Change No. 12
License No. DPR-22

SAFETY EVALUATION BY THE DIRECTORATE OF LICENSING

NORTHERN STATES POWER COMPANY

CHANGE NO. 12 TO TECHNICAL SPECIFICATIONS

FIGURE 2.1.1 FUEL CLADDING INTEGRITY SAFETY LIMIT

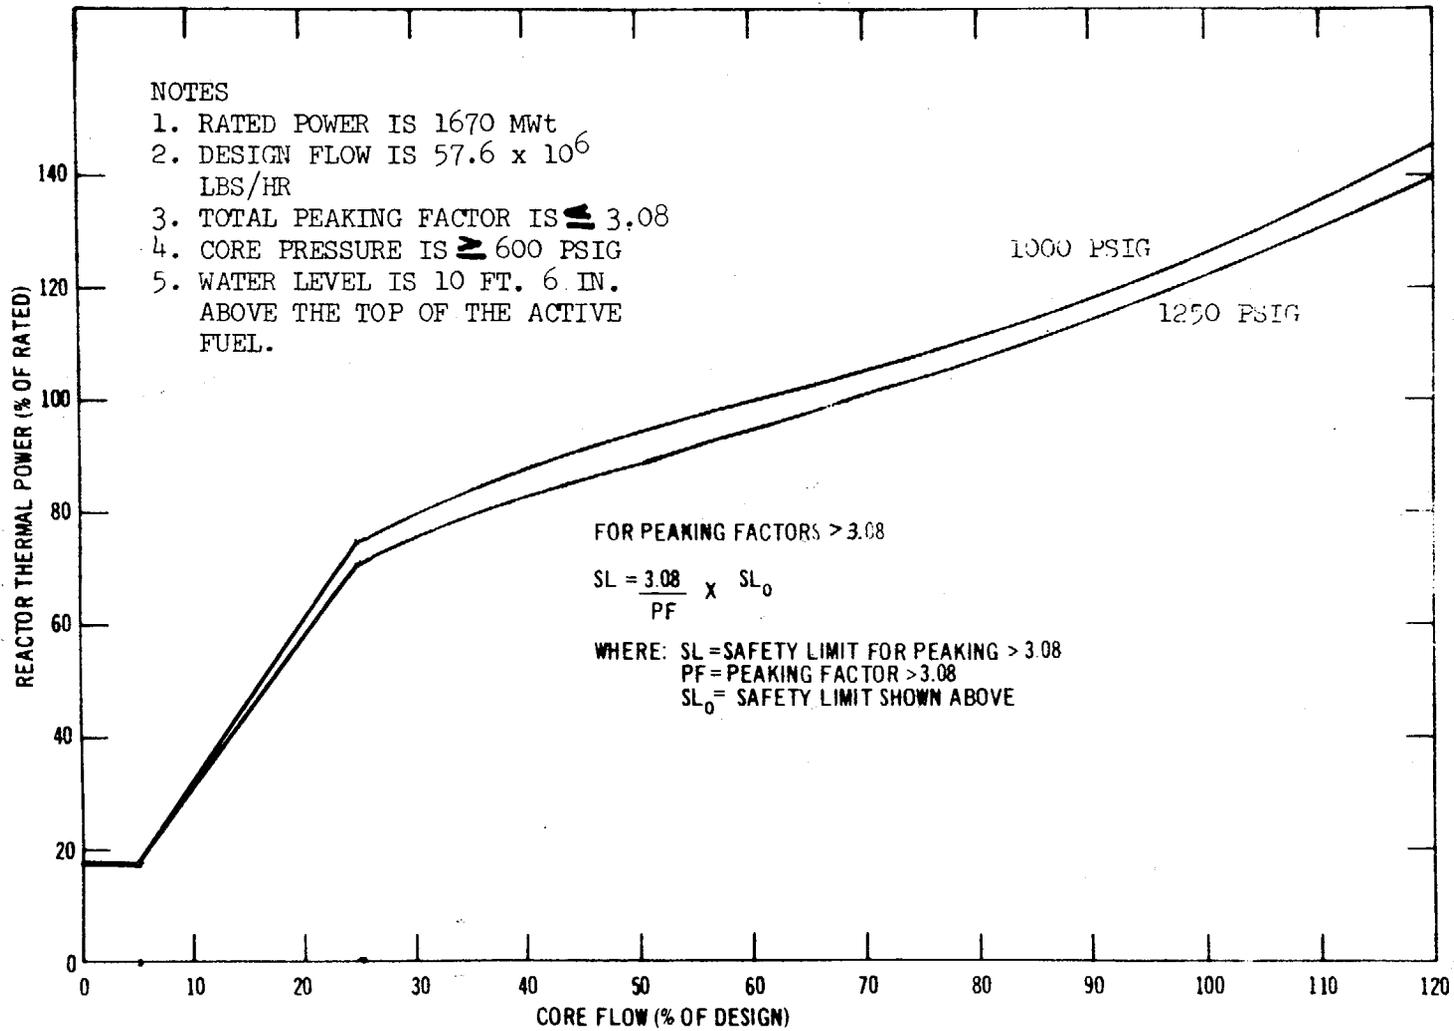
We compared the proposed change to the fuel cladding integrity safety limit (Specification 2.1.B) of 5 percent design core flow with other BWR plants of similar design, such as Vermont Yankee. We concluded that the proposed change is acceptable and is consistent with the requirements of other BWR plants.

FIGURE 3.4.1. Sodium Pentaborate Solution Volume
— Concentration Requirements

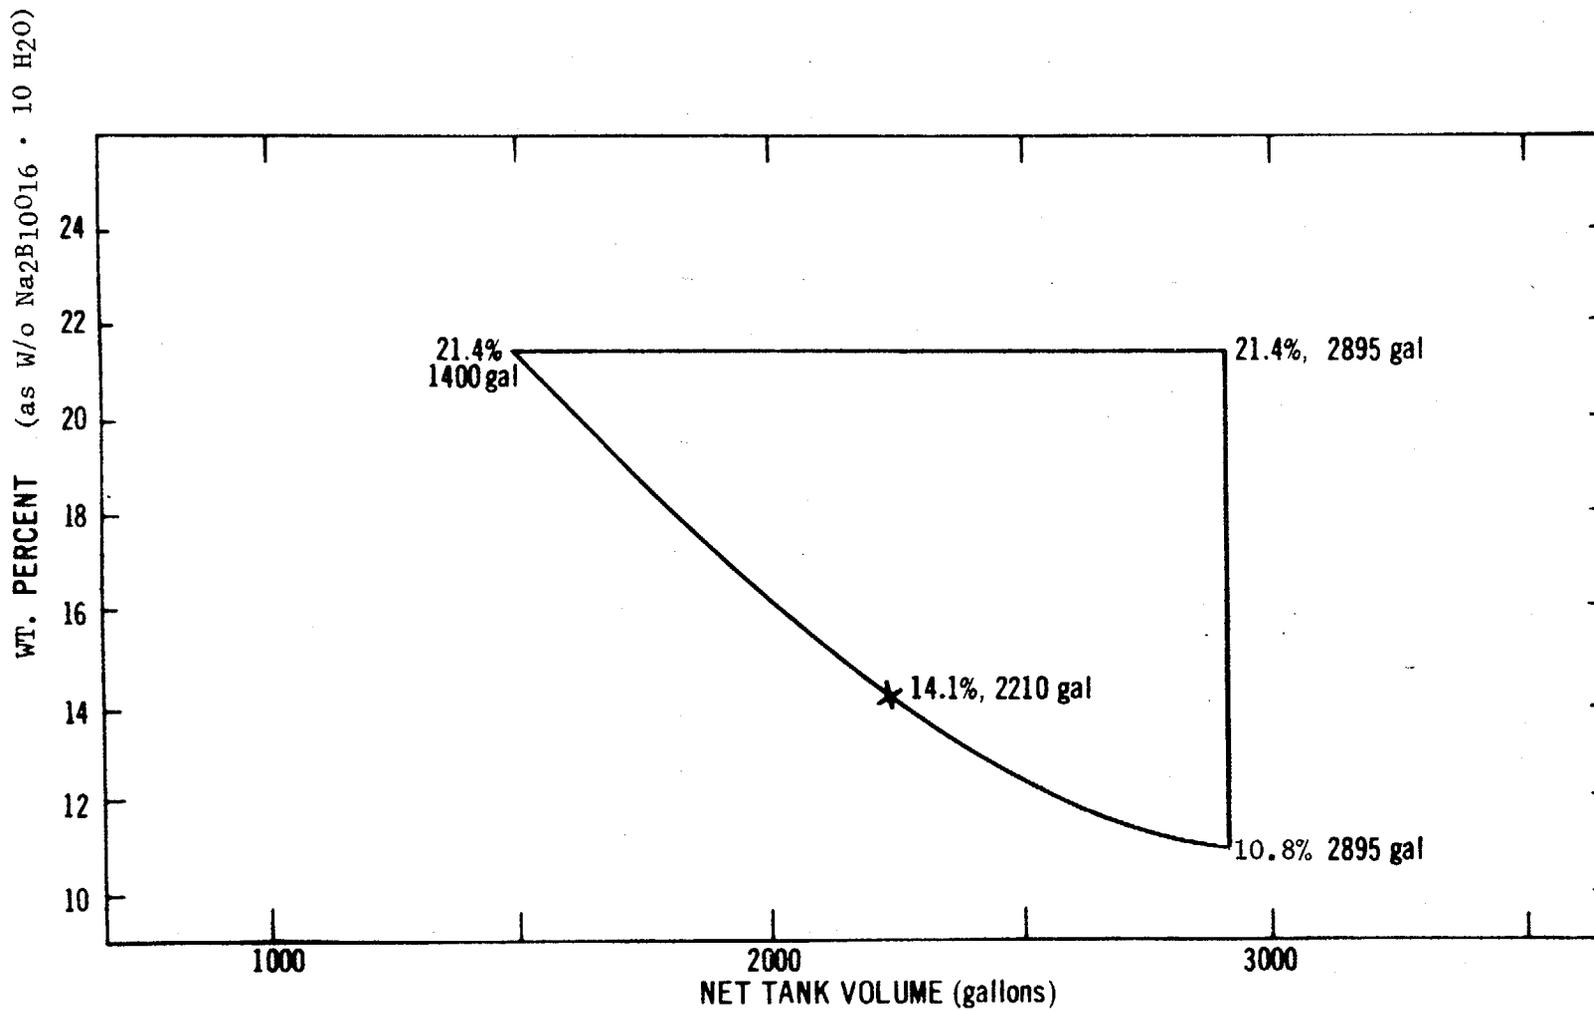
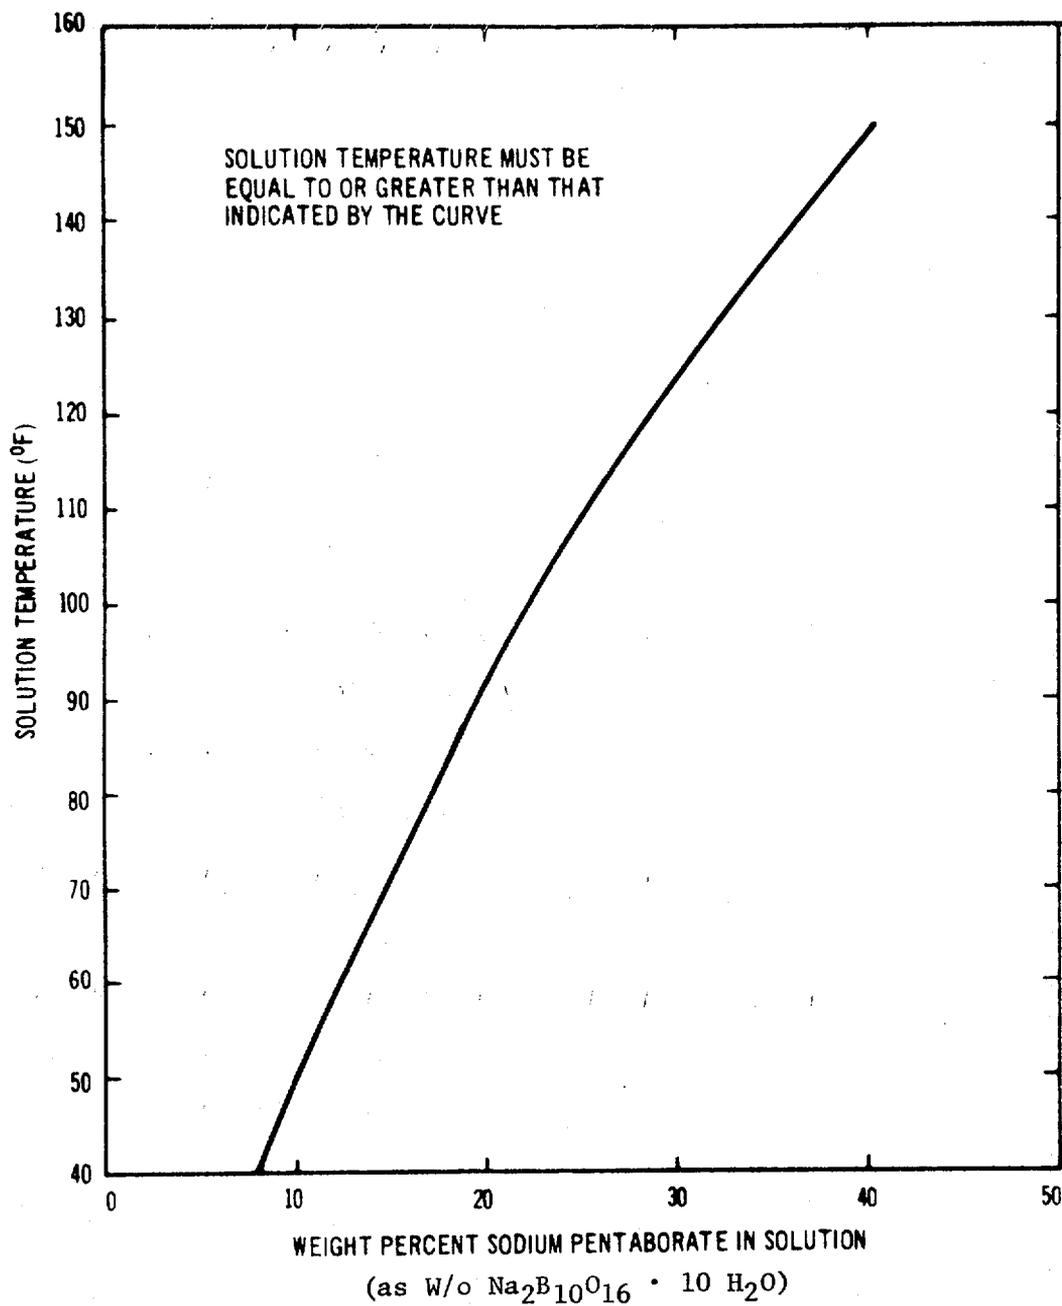
We have reviewed the proposed changes to Figures 3.4.1 and 3.4.2 regarding liquid poison volume concentration requirements. We have concluded that the proposed changes are consistent with current Regulatory requirements and identify the chemical form of the liquid poison.
